Proposed Garage Location Detail Septic Field & Well Location
 4815 Manor Lane, Lot 8 Klein & Linn Property, 2nd Election District, Howard County MD
 Ref: Dwg # X16391
 NTT Assoc. Inc, 16205 Old Frederick Rd, Mt Airy MD 21771, 28 Aug 1992
 Date: 24 June 2005 REV A Drawn by: HJH SCALE: 1" = 75'

SEWAGE DISPOSAL SYSTEM
MARYLAND STATE DEPARTMENT OF HEALTH*

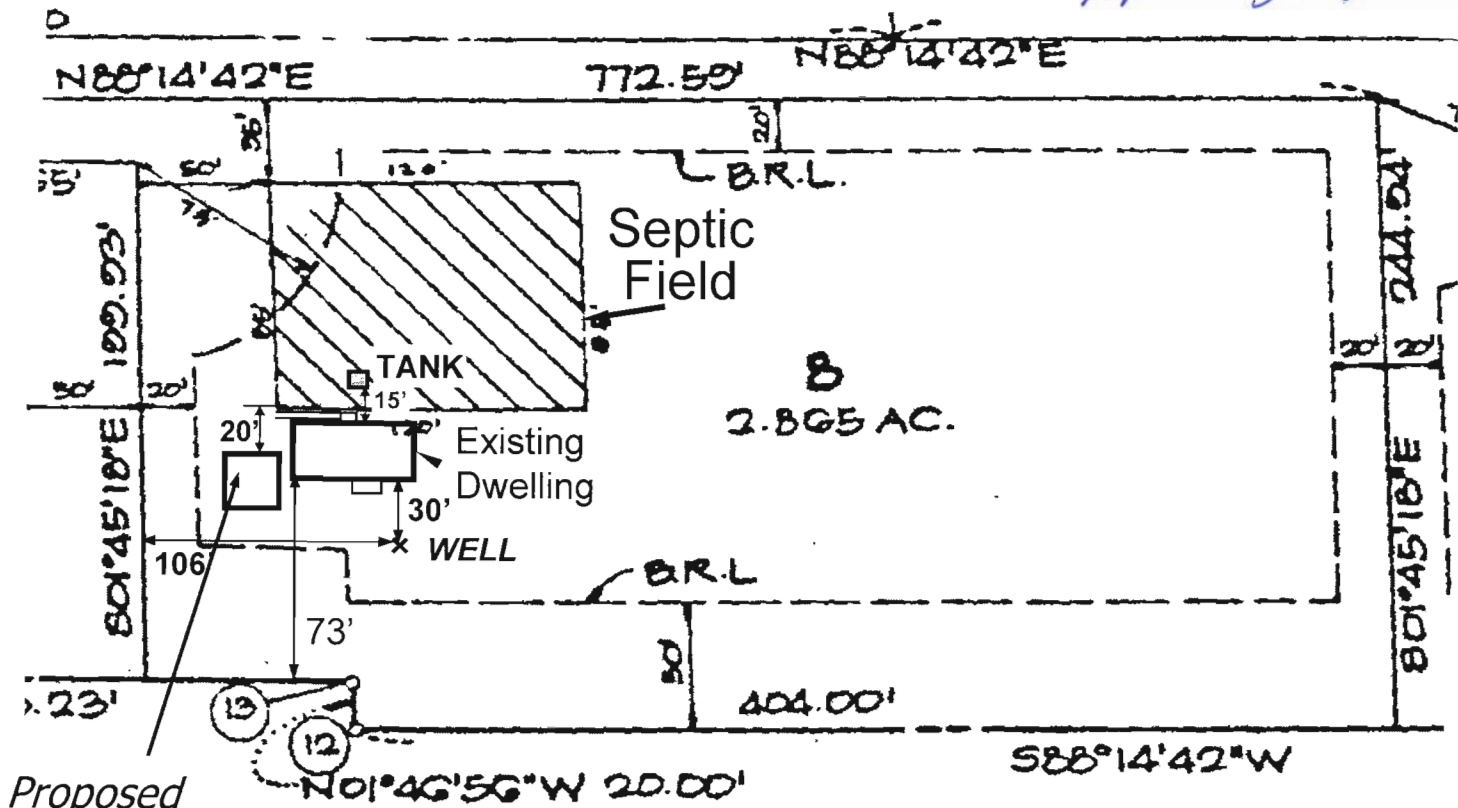
Note: Garage moved southward 5' to comply with min separation requirement (20') from septic field

6/27/05 00054218
 Proposed garage location ok
 (KJB)
